**TOWN OF LEESBURG  
TOWN COUNCIL WORK SESSION**

**Subject:** Referral Requests from Loudoun County on: 1) ZMAP 2012-0011, Tuscarora Crossing and 2) ZMAP 2013-0005, Goose Creek Golf Club; SPEX 2013-0017, Goose Creek Golf Course; SPEX 2013-0018, Hotel; and 2013-0019, Restaurant

RE: Referral Request for ZMAP 2012-0011, Tuscarora Crossing, 3<sup>rd</sup> Submission

**TO:** Susan Berry Hill, Director of Planning & Zoning  
**FROM:** Calvin K. Grow, P.E., Transportation Engineer *CA*  
**DATE:** September 13, 2013  
**RE:** Tuscarora Crossing, 3<sup>rd</sup> Submission (ZMAP 2012-1011)

**CONCEPT DEVELOPMENT PLAN**  
**TUSCARORA CROSSING**  
**ZONING MAP AMENDMENT**  
**ZMAP 2012-001**

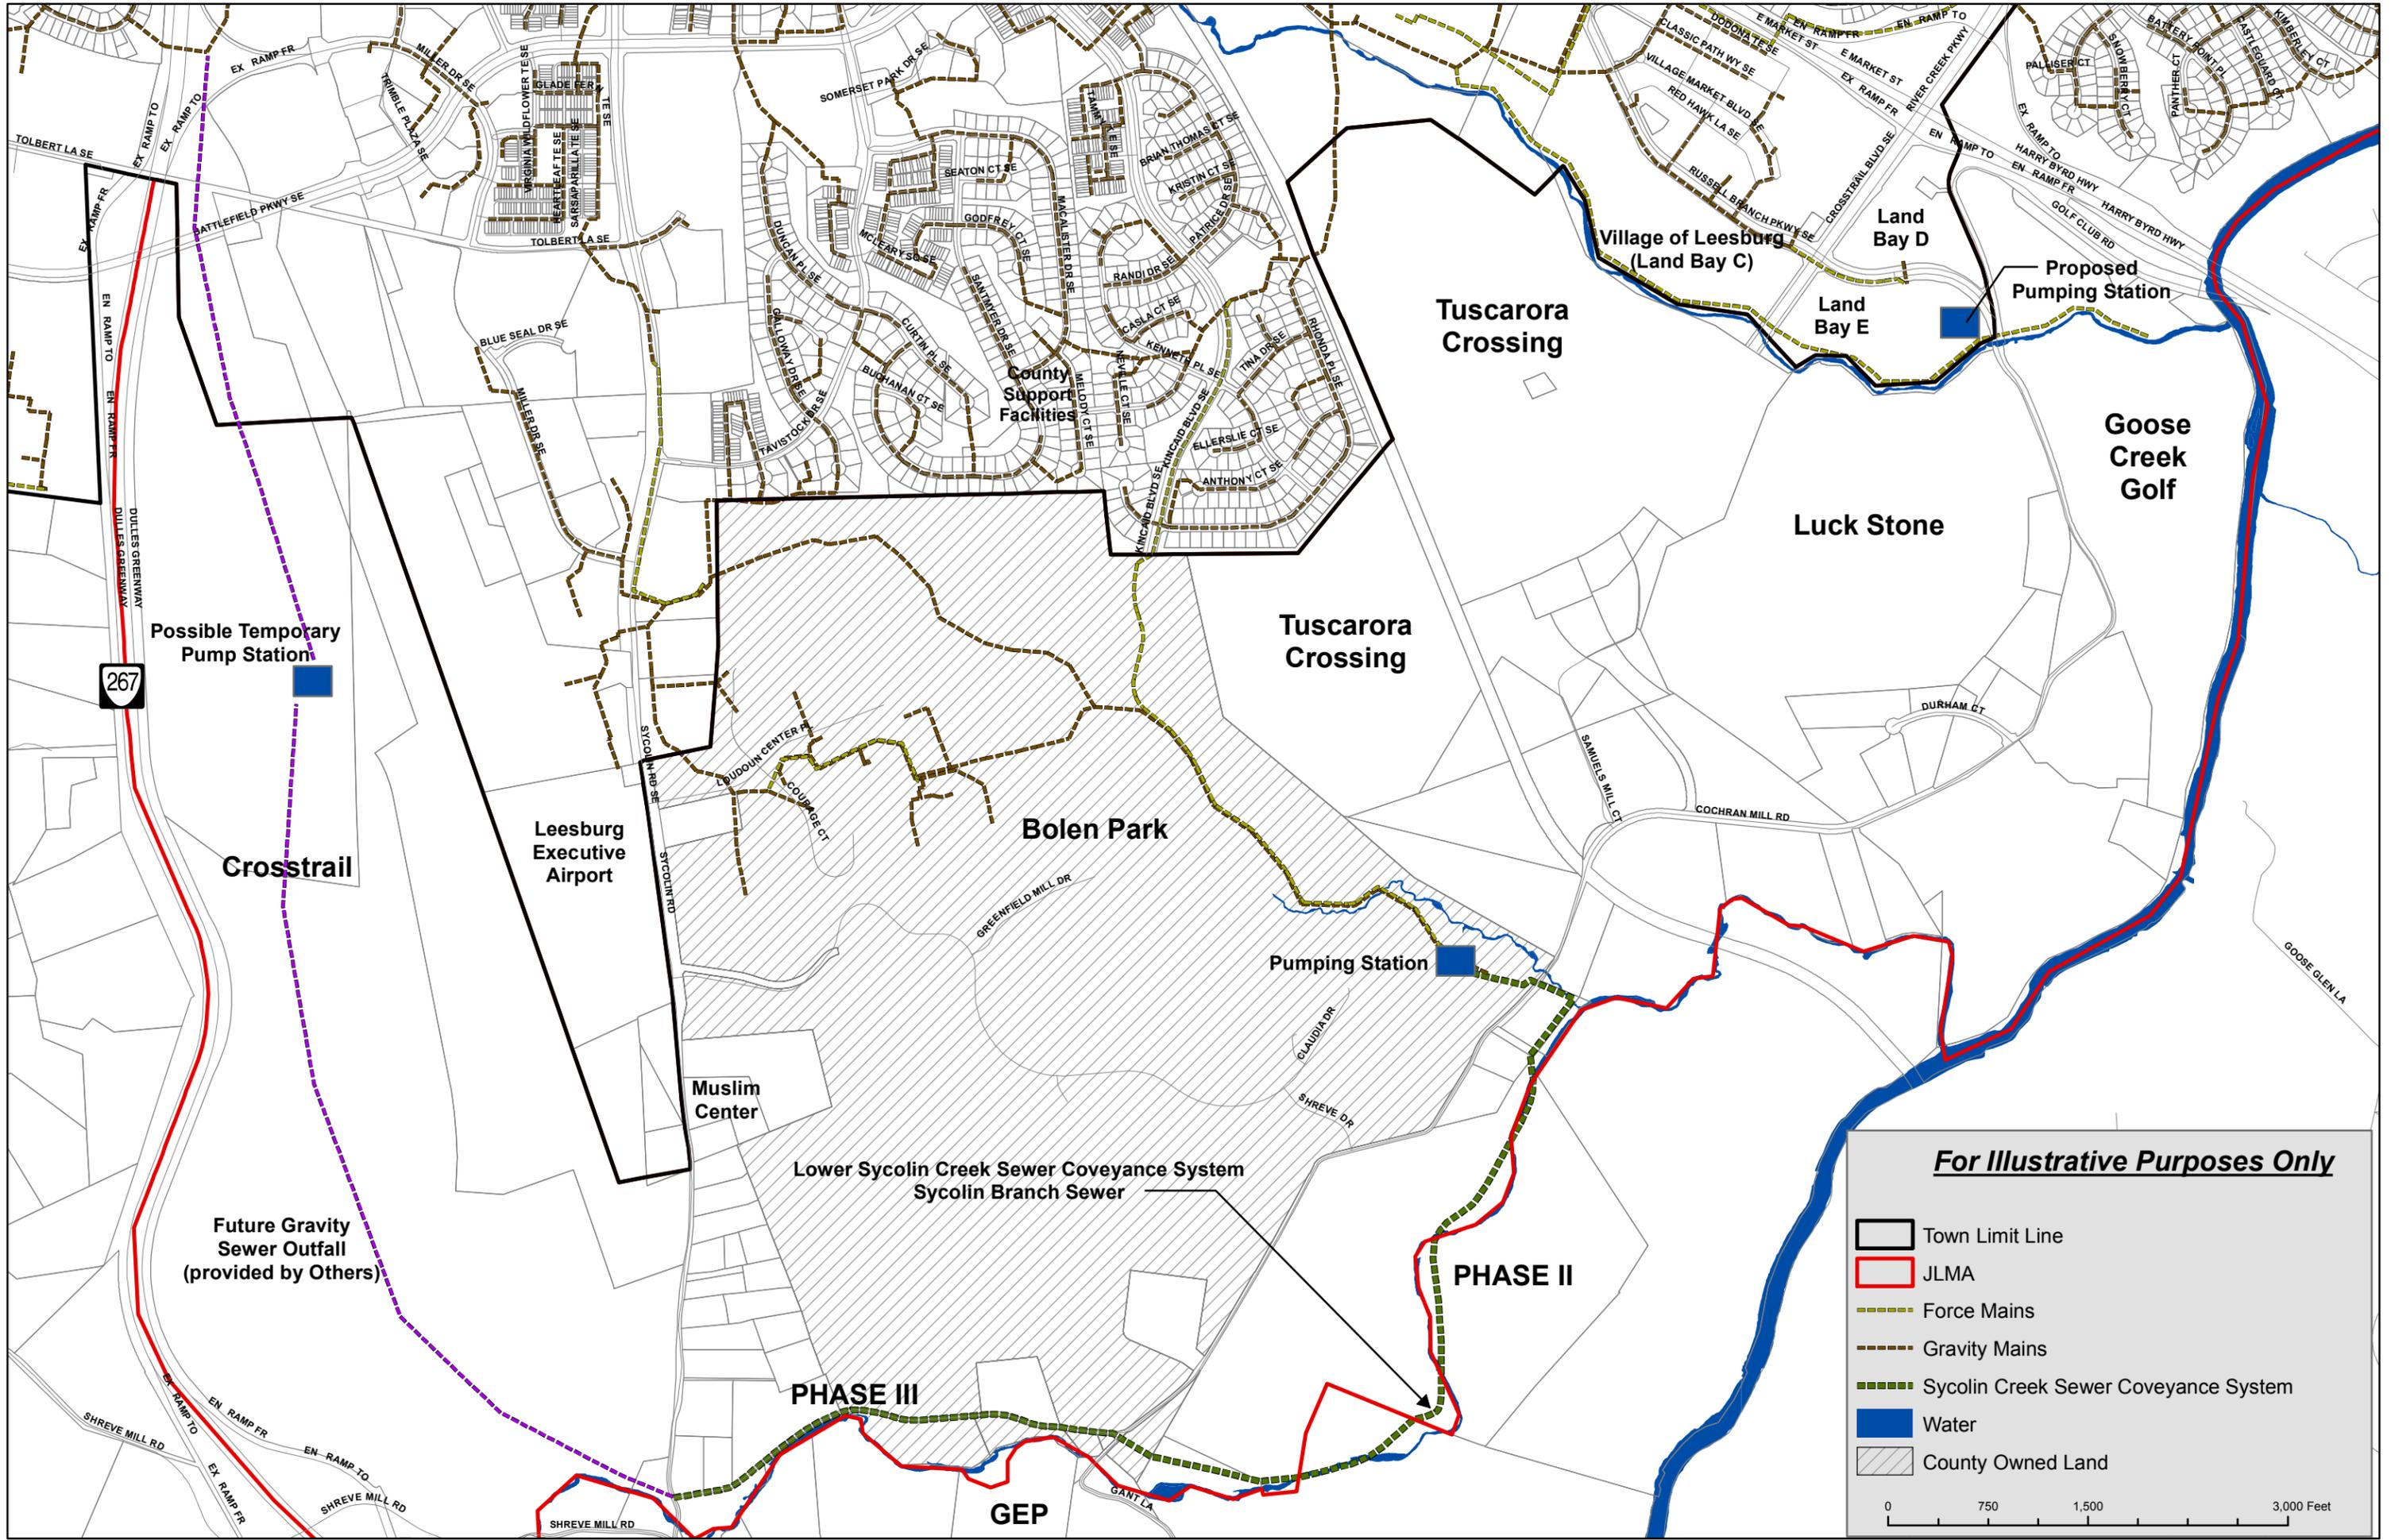
1. The 2<sup>nd</sup> submission plan is substantially different from the first submission given the inclusion of an elementary school site on Land Bay 4 and a commercial site on Land Bay 5, both of which are located on the east side of Crosstrail Boulevard. Open space was shown with the first submission for Land Bay 4 and residential use for Land Bay 5. This land use change will affect the utility planning for the site. The applicant must demonstrate how water and sewer will be provided to these Land Bays.

*The proffers (I) states that the applicant will pay for the cost of providing water and sewer to the site. However, there is still no detail provided for how the site will be served. The applicant should depict how the land bays will be served with water service. Water loops should be accomplished for service reliability and safety. Provision of one connection point to the water system will not satisfy this requirement. Utility system design at this stage of development needs to provide*

*reasonable assurance to the Town that the applicant has a workable plan for utility service. The Town has no such assurance with this third submission.*

7. Explain the labeling of Crosstrail Blvd. as “Rt. 653 Relocated” on the ZMAP. (Sht. 3). *Note that Crosstrail Blvd. is a planned “major arterial” roadway and not a “collector” street as currently represented on the Concept Development*

*Plan. The application does not address the construction phasing of the portions of Crosstrail Boulevard that this project proposes to construct, including the bridge over the Tuscarora Creek that will complete Crosstrail Boulevard to Russell Branch Parkway. This portion of Crosstrail Boulevard is located almost entirely on the Applicant's property (with only a minor offsite portion at the Village at Leesburg where all ROW has already been dedicated). The Town of Leesburg is extremely concerned that if the applicant does not construct all four lanes, the traffic from this development will be diverted to existing town roads (which could be problematic) and any missing links would need to be constructed at the Town of Leesburg's taxpayer expense at a later date should this property ever be brought into the Town's Corporate Limits. Therefore, staff recommends that the applicant proffer to design, phase and build a 4-lane section of Crosstrail including the bridges that complete Crosstrail Boulevard to Russell Branch Parkway and all required turn lanes along Crosstrail Boulevard. Regarding phasing, staff recommends that the Applicant design the entire 4 (four) lane section and build a minimum of 2 (two) lanes as well as the required turn lanes of Crosstrail Boulevard including all bridges from its' terminus near Russell Branch Parkway through the entirety of the Applicant's property prior to the issuance of the "first" residential occupancy permit. The remaining portion of the 4 (four) lane section of Crosstrail Boulevard would then need to be constructed (including all bridges and associated turn lanes) prior to the issuance of the 541<sup>st</sup> (75%) residential occupancy permit for this development.*

*AS was previously noted, this portion of Crosstrail Boulevard is located almost entirely on the Applicant's property (with only a minor offsite portion at the Village at Leesburg where all ROW has already been dedicated) the developer of Tuscarora Crossing needs to construct all 4 lanes of Crosstrail Boulevard. The proffer language provided with this submission is unclear as to what portions are to be constructed in what order and thus should be clarified. In addition, all required ROW, and any required Permanent and Temporary Easements necessary to construct Crosstrail Boulevard should be dedicated with the first phase of the development.*
